# Work Order ID 119541

Item Name: Fwd Crosstube - High

Draw Nbr	Revision Nbr
D212-664-141	Rev D (DEO)

DRAWING NO. D212-664-141	TITLE XTUBE ASSY (205/212/412 HI FWD)	REV. D	DART AEROSPACE LTD ENGINEERING ORDER		D.E.O. NO. D212-664-141-D-1	SHEET NO. SHEET 1 OF 2	SCALE NTS
DRAWN	CHECKED	MP	MFG. APPR.	BE	APPROVED	MP	DE APPR.
DATE 11.04.07	DATE 11.07.11		DATE 11.04.12		DATE 11/04/12		DATE 11.04.12

**D212-664-141/-141B**  
**ASSEMBLY DETAIL**

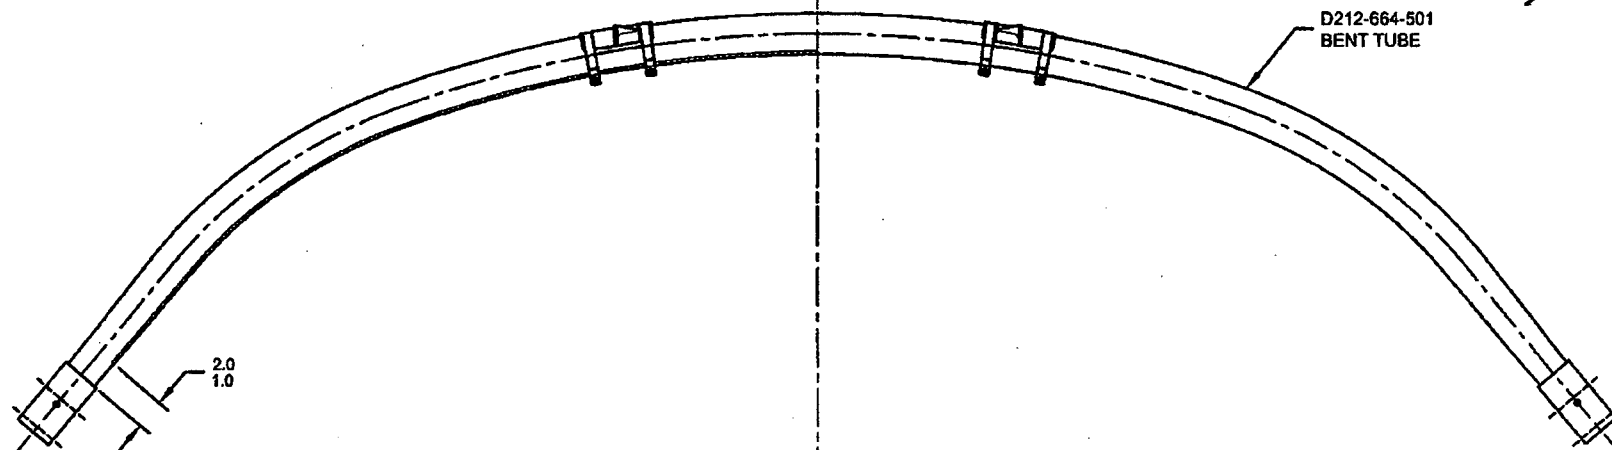
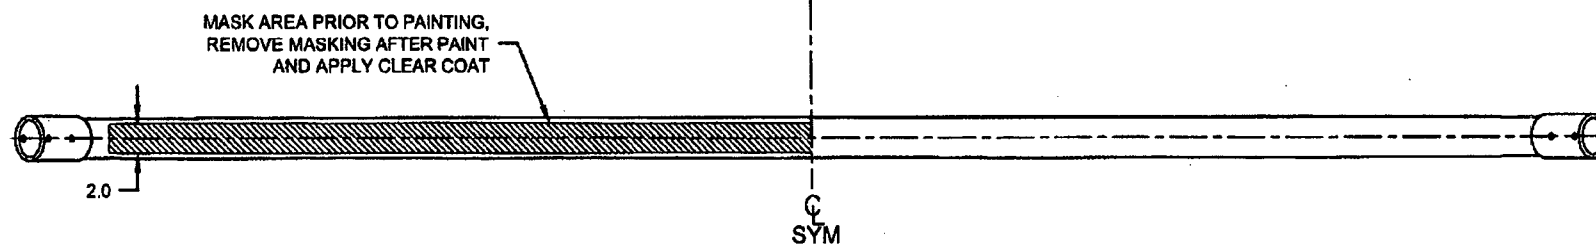
ADD AN INSPECTION WINDOW TO UNDERSIDE OF CROSSTUBE.

NOTES 2 OF SHEET 1 IS AMENDED AS FOLLOWS:

- 2) FINISH: CHEMICAL CONVERSION COAT PER DART QSI 005 4.1  
PRIME INSIDE AND OUTSIDE PER DART QSI 005 4.2  
MASK UNDERSIDE OF CROSSTUBE AS SHOWN (HATCHED AREA) AND  
PAINT OUTSIDE PER DART QSI 005 4.2  
REMOVE MASKING AND APPLY CLEAR COAT

**IS:**

**WAS:**

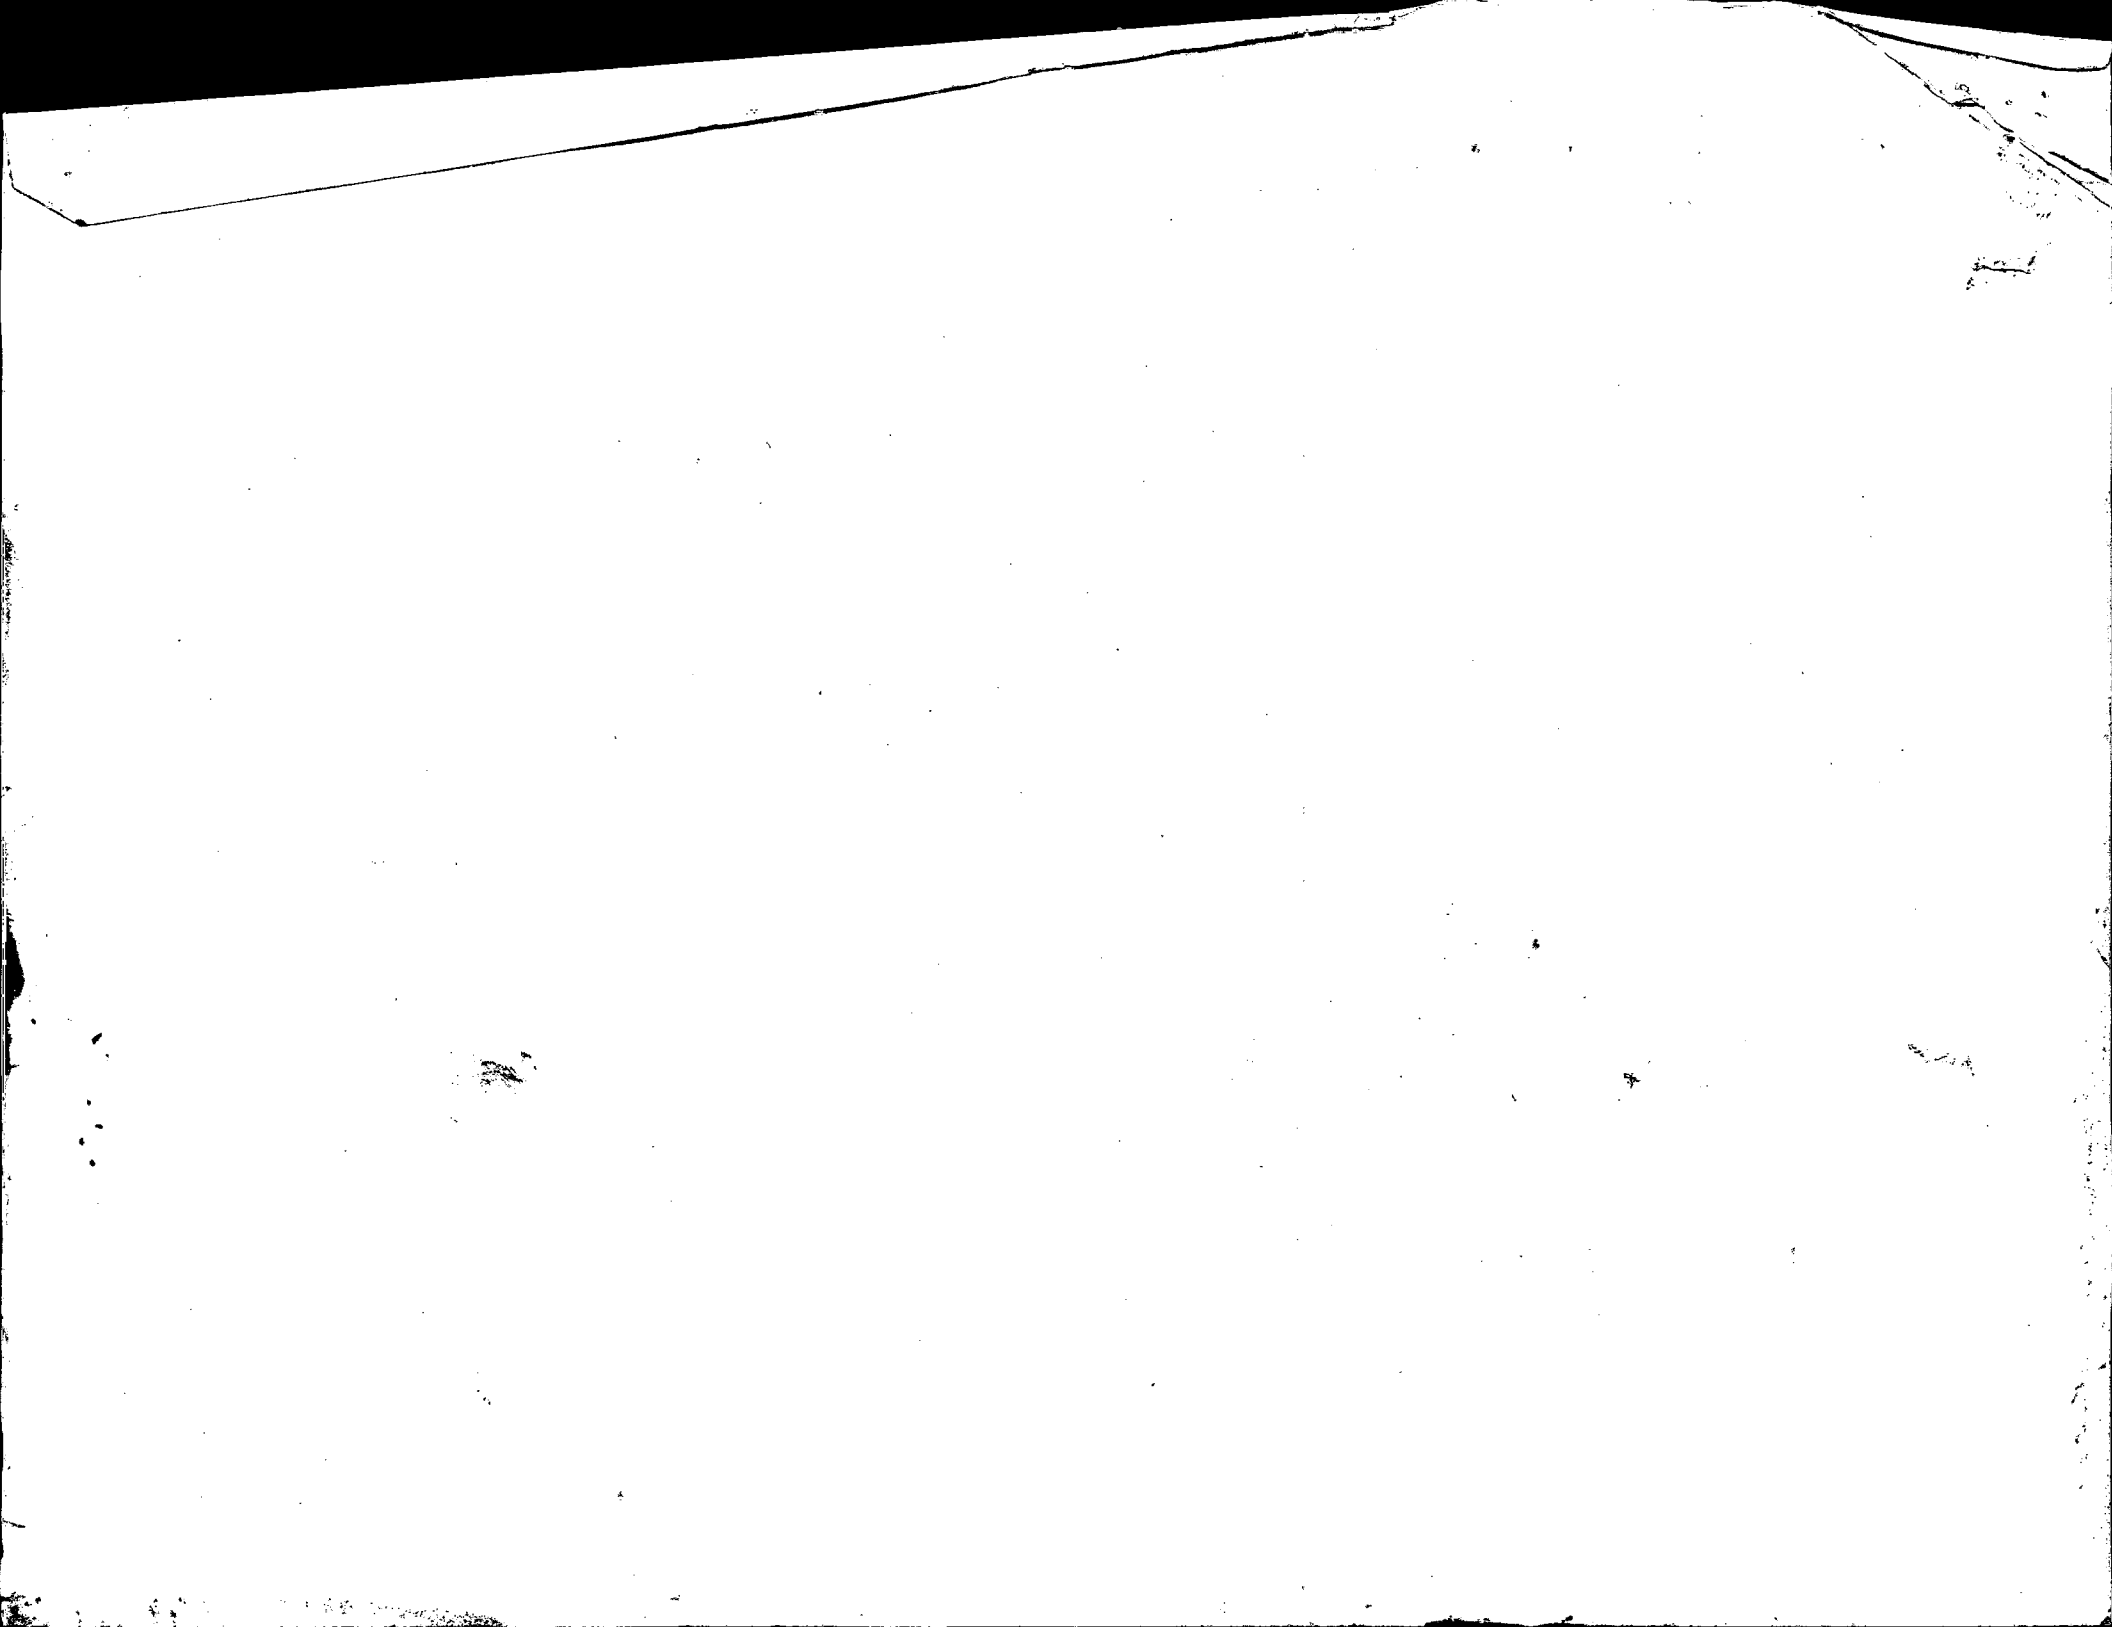
- underbent midde by approx 0.060". was UNABLE to reach nominal dimensions. scrapped tube after rebending middle to achieve nominal dimensions. "midde fix after sides are bent" was over effective, it runs from centre line out. therefore. DO NOT underbend middles, and use caution if using "middle fix after sides are bent" program. jw 12/6/1

14/02/26.. Bent 4 tubes, (Ran 212fMauto, Mfix, Mfix2) middle finished even to outline on new board.
